UNITED STATES PATENT AND TRADEMARK OFFICE

APPLICATION NO.	FILING DATE	FIRST NAMED INVENTOR	ATTORNEY DOCKET NO.	CONFIRMATION NO.
09/621,975	07/21/2000	Noah P. Montena	8958-0026	5489

**Office Action Summary**Application No.  
**09/621,975**Applicant(s)  
**Montena**Examiner  
**Renee S. Luebke**Art Unit  
**2833**

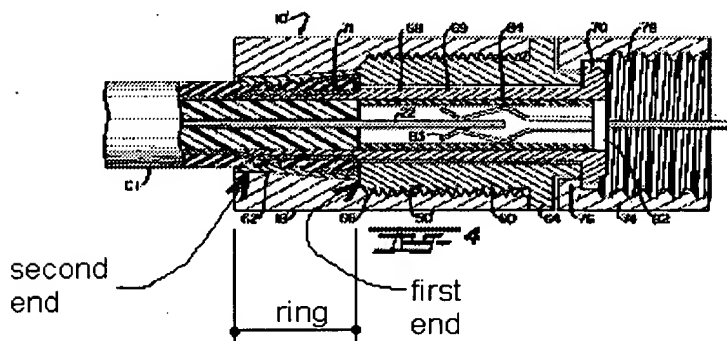
3. Independent claims 2, 10, 11, 13 and 14 are no longer rejected as being anticipated by Holliday '220 based in the interpretation discussed during the telephone conversation on September 6, 2001 and applicant's arguments of September 20, 2001. In that regard, the connector of Holliday was for coupling the end of a coaxial cable C1 having a center conductor 22, a dielectric, a grounding sheath and an outer protective jacket. The connector comprised a tubular post 69 with a first end 71 inserted into the

end of the cable, and an opposed second end 70; and a nut 74 rotatably engaging the second end of the post and having an opposed second end with internal threads 78. The connector further comprised a cylindrical body member 60 having a sleeve with a first and second end (as marked at left). The first end was seen to be coextensive with the sleeve and also the open rear end portion, as defined in the claims. The outer wall of the open rear end portion comprised the external wall of the

body member for the entire length of the first end. Similarly, the inner wall of the open rear end portion comprised the inner wall extending the entire length of the first end. The connector further comprised a compression ring 18' having first and second ends. The first end of the compression ring was in the same range as the first end of the body member. The second end of the compression ring was the remainder of the ring (to the right of the first end). As the internal bore of the first end of the compression ring and the outer wall of the open rear end portion (the first end) essentially abut each other as

shown on the figure, they were seen to be commensurate as claimed. However, interpreted in this manner, the compression ring lacks an inwardly tapered annular wall leading from the first internal bore. Since the taper of Holliday is part of the first internal bore, it does not lead therefrom.

4. However, interpreting the reference in a different manner, Claims 2, 8, 10, 12 and 15-20 are rejected under 35 U.S.C. 102(e) as being anticipated by Holliday '220. The connector of Holliday is for coupling the end of a coaxial cable C1 having a center conductor 22, a dielectric, a grounding sheath and an outer protective jacket. The connector comprises a tubular post 69 with a first end 71 inserted into the end of the cable, and an opposed second end 70; and a nut 74 rotatably engaging the second end of the post and an opposed second end with internal threads 78. The connector further comprises a cylindrical body member 60 with a sleeve 62 and an open rear end portion

at the left end. The second end of the body member (the right end) engages the second end 70 of the post at its second end. The compression ring (indicated at left) has first and second ends as shown.

Between the ends, the ring comprises an inwardly tapered annular wall that causes deformation of the sleeve. It is noted that the threaded portion to the right of the compression ring is seen to be an attachment part of the splicing device and not a part of the compression ring.

In regard to claim 8, the body member of Holliday comprises an enlarged shoulder just to the left of the beginning of the tread 66.

In regard to claim 10, the thinner section to the right of rib 38 (see Fig. 1 for reference numeral 38) is seen to be a relief that facilitates bending of the sleeve.

In regard to claim 12, the sleeve of Holliday comprises a corrugated portion 38, 40. As this structure assists in compressing the cable, it is also seen to facilitate movement of the sleeve.
